Sean Briski  
1226 Vista Court  
Glendale, CA 91205  
Tel. 323-828-5784

**Regarding: Proposed single family residence near oak tree**

**ADDENDUM  
INDIGENOUS OAK TREE  
TREE PROTECTION PLAN**

**INDIGENOUS OAK TREE  
TREE PROTECTION PLAN**

**6**  
 SITE PLAN  
 SCALE = 1/8"=1'-0"

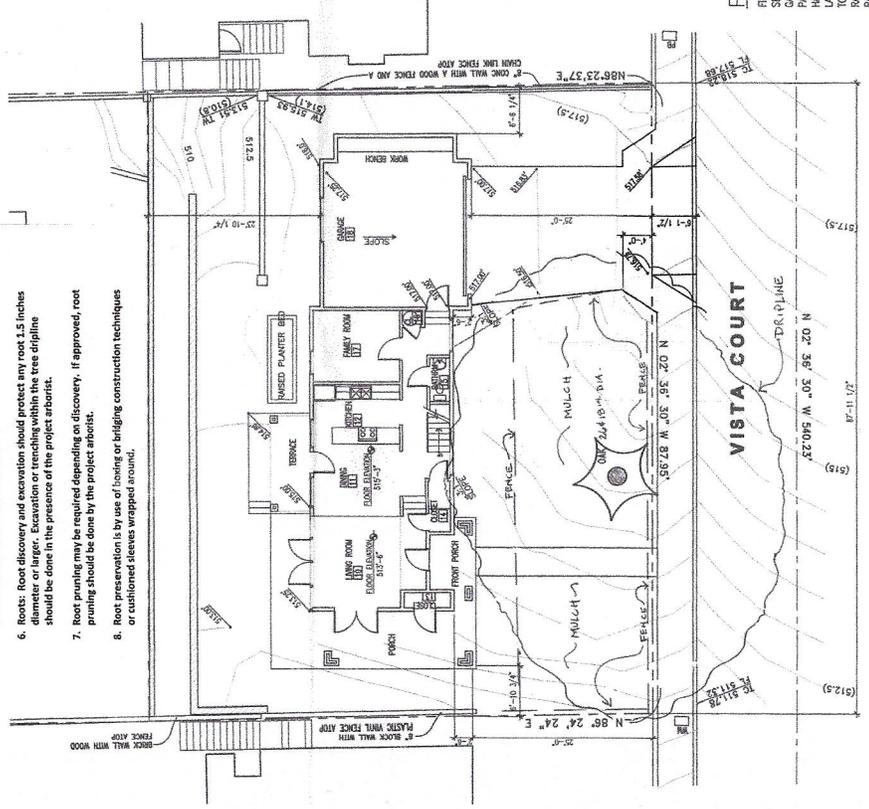
This addendum is made to discuss a slight modification to the plan layout of a residential driveway in relation to a regulated Coast Live Oak, *Quercus agrifolia*, at 1226 Vista Court. The new driveway is to be located within the south crown and tree protection zone due to location of the tree and limited site layout options.

The driveway modification is due to a City of Glendale mandated sidewalk access addition that fills a small triangular section where the driveway joins the sidewalk. The additional sidewalk access is east of the sidewalk and inside the residential front yard, south of the tree trunk.

The new concrete layout is ultimately a minor additional encroachment into the protected zone of the oak tree. The nearest edge of new concrete will be placed approximately 24 feet south of the tree trunk. Large tree roots (2 inches or larger) are not anticipated at this distance from the trunk. Thus, the tree is expected to weather the proposed construction encroachments without significant negative impacts as long as protections are put in place per the original tree preservation plan of September 2019 especially the first three items repeated here.

1. Fence: Tree protection fences should be placed along:
  - Property line west and north sides.
  - 6 feet off the new wall of the house.
  - 1 foot inside the edge of the new driveway.
2. Fence: Barriers should be constructed of chain link fencing 5-6 feet in height to exclude soil compaction within the dripline. All construction activities should be kept outside the tree protection barriers including foot traffic, equipment operation, material transport, material storage, and trenching.
3. Mulch: Apply a 4 inches depth mulch layer over the entire area within the dripline. Coarse wood chips or equal are recommended.

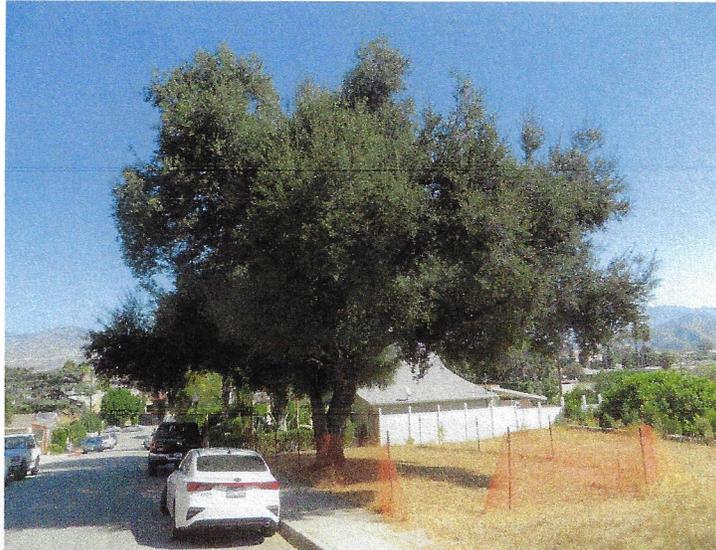
A new single family residence is proposed to the east (right). The home encroaches approximately three feet into the tree protection zone. Clearance pruning will be required and should be monitored.

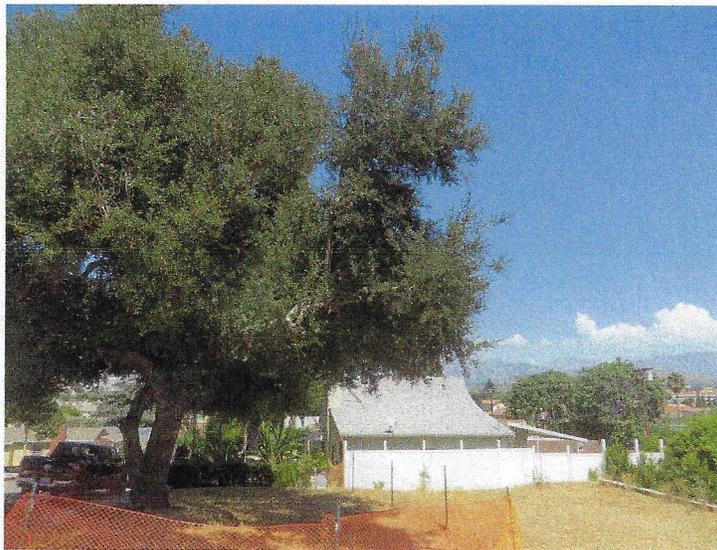
Older pruning wounds are observed on the trunk.

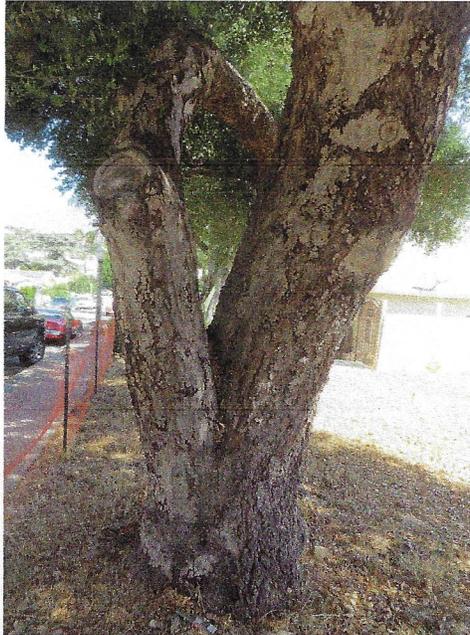
A newer pruning wound of approximately July of 2018.
